# UNITED STATES PATENT AND TRADEMARK OFFICE

10/537,399

Alan H. Winfield

<b>Office Action Summary</b>	<b>Application No.</b> 10/537,399	<b>Applicant(s)</b> WINFIELD, ALAN H.	
	<b>Examiner</b> BRYAN EPPES	<b>Art Unit</b> 3635

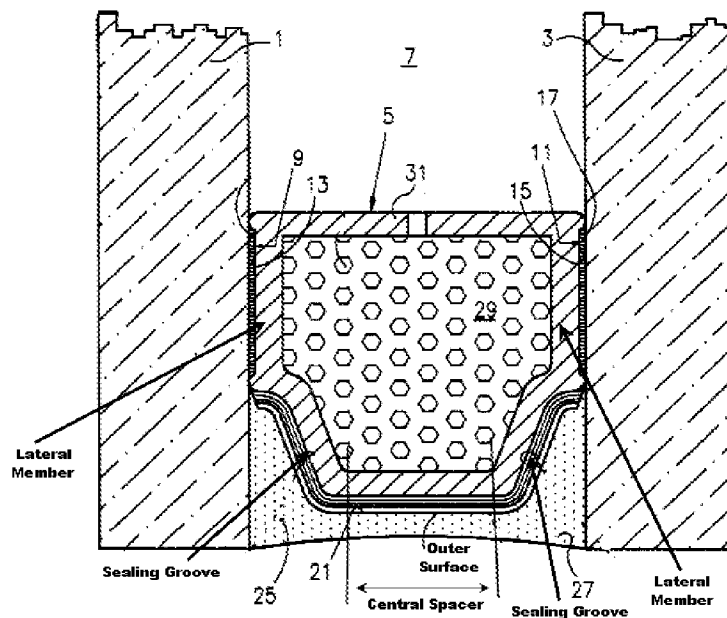
2. Claim 1 is rejected under 35 U.S.C. 102(b) as being anticipated by Trautz (U.S. Patent 5,962,090).

- a. Claim 1: Trautz discloses an insulation window comprising:
- i. A pair of outer panes 1 and 3 defining an air space therebetween;
  - ii. A spacing member 5 disposed between the outer panes comprising a central spacer and opposing lateral members, wherein the central spacer engages and separates the opposing lateral members and at least one lateral member comprises a means for retaining an interior film, shown as the sealing mass in either contact surface 9 or 11 which is capable of sandwiching a film (e.g. tinting) between a pane and the spacing member 5, wherein the spacing member further comprises an outer surface extending between lateral members;
  - iii. Wherein each lateral member defines a sealing groove;
  - iv. A gas-tight seal element 27, described as preferably polysulfide or silicone, contained within each sealing groove; and

- v. A metal band 21 parallel to and overlaying the outer surface, wherein the band comprises edge flanges which fit into the sealing grooves, thereby isolating the central spacer outer surface from the seal element 27 (See Modified Fig. Above; Fig. 1).

c. Applicant argues the '090 Patent lacks a central spacer, opposing lateral members and means for retaining an interior film. Examiner respectfully disagrees. The specific features are set out in the modified figure and claims above.

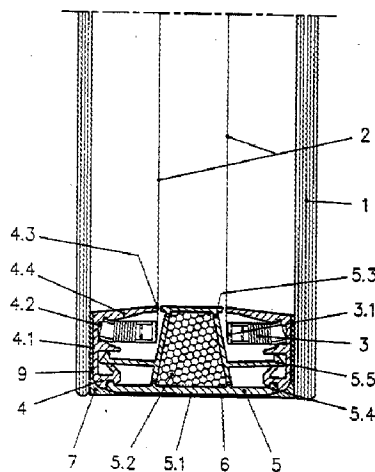
3. Claims 1 and 2 are rejected under 35 U.S.C. 103(a) as being unpatentable over Grether, deceased et al. (U.S. Patent 5,237,787) in view of Trautz (U.S. Patent 5,962,090).

- b. Claims 1 and 2: Grether, deceased et al. discloses an insulation window comprising:
- vi. A pair of outer panes 1 defining an air space therebetween;

- vii. Wherein the spacing member comprises a central spacer, described as separation profile 5, and opposing lateral members, described as tension profiles 4, wherein the central spacer 5 engages and separates the opposing lateral members 4 and at least one of the lateral members 4 comprises means for retaining an interior film 2, described as weld-caps 3.1 and helical springs 3 (See unmarked Fig.), wherein the spacing member further comprises an outer surface 5.1 extending between the lateral members;

- viii. Wherein each lateral member 4 defines a sealing groove 7 (Col. 4 Lines 50-53).
  - ix. A gas-tight seal element, described as a butyl adhesive (Col. 4 Line 46), contained within each sealing groove 7;

- x. A metal band 6, described as rust-proof stainless steel (Col. 4 Line 45), parallel to and overlaying the outer surface (See Unmarked Fig.).

Grether, deceased et al. lacks a metal band comprising edge flanges which fit into the first and second sealing groove. Trautz teaches a metal band (Trautz Ref. # 21) comprising edge flanges which fit into the first and second sealing grooves to provide an improved adhesive bond between the non-butyl sealing mass and the spacer member. Therefore, it would have been obvious to

one of ordinary skill in the art, at the time of the invention, to modify the metal band of Grether, deceased et al. with a band that includes flanges which extend into the first and second grooves to provide an improved adhesive bond between the non-butyl sealing mass and the spacer member.

d. Applicant argues the '787 Patent lacks a central spacer is not separated into a central spacer and opposing lateral elements. Examiner respectfully disagrees. See features 5 and 4 of '787 set out in the claims above.
